Access Compliance Report

Public Rights-of-Way

(Curb Ramps)

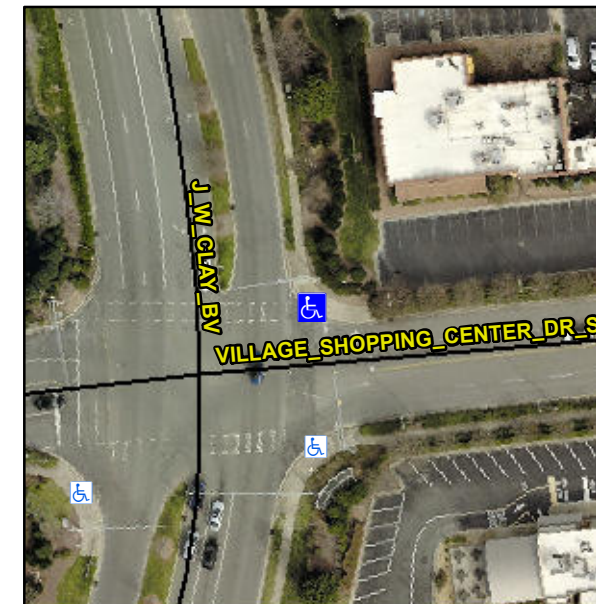
Intersection ID: 30083	Main Street: J_W_CLAY_BV	Cross Street: VILLAGE_SHOPPING_CENTER_DR_S	Location: NE
ADA ID: 8E5846966F39	Ramp Type: Perpendicular	Initial Pass/Fail: Fail	Overall Compliance: No
Severity Score: 17.5			
Codes/Mitigation Info/Possible Solution		Field Measurements/Component Compliance

R304.5.1

Compliance	Description	Data	Compliance	Description	Data
N/A	Ramp Length (in)	112.0	Yes	Ramp Slope (%)	7.2
No	Ramp Width (in)	33.0	Yes	Ramp XSlope (%)	1.3
N/A	Flare Type LT	N/A	N/A	Flare Type RT	N/A
N/A	Flare Slope LT (%)	N/A	N/A	Flare Slope RT (%)	N/A
N/A	Flare Traversable LT?	N/A	N/A	Flare Traversable RT?	N/A
N/A	Landing Length (in)	N/A	N/A	DWS Provided?	N/A
N/A	Landing Width (in)	N/A	N/A	DWS Contrast?	N/A
N/A	Landing Slope (%)	N/A	N/A	DWS Length (in)	N/A
N/A	Landing X Slope (%)	N/A	N/A	DWS Full Width?	N/A
N/A	Landing Curb? (Y/N)	N/A	N/A	DWS Offset (in)	N/A
N/A	Shared Landing?	N/A			
N/A	Gutter Ponding?	N/A	N/A	Gutter Slope (%)	N/A
N/A	Gutter Lip Ht (in)	N/A	N/A	Gutter X Slope (%)	N/A
N/A	Painted X Walk1?	No	N/A	Painted X Walk2?	N/A
	X Walk 1 Direction	To S		X Walk 2 Direction	N/A
N/A	X Walk 1 Width (in)	N/A	N/A	X Walk 2 Width (in)	N/A
	X Walk 1 Slope (%)	1.6		X Walk 2 Slope (%)	N/A
	X Walk 1 X Slope (%)	3.3		X Walk 2 X Slope (%)	N/A

Remove & Replace Entire Ramp.
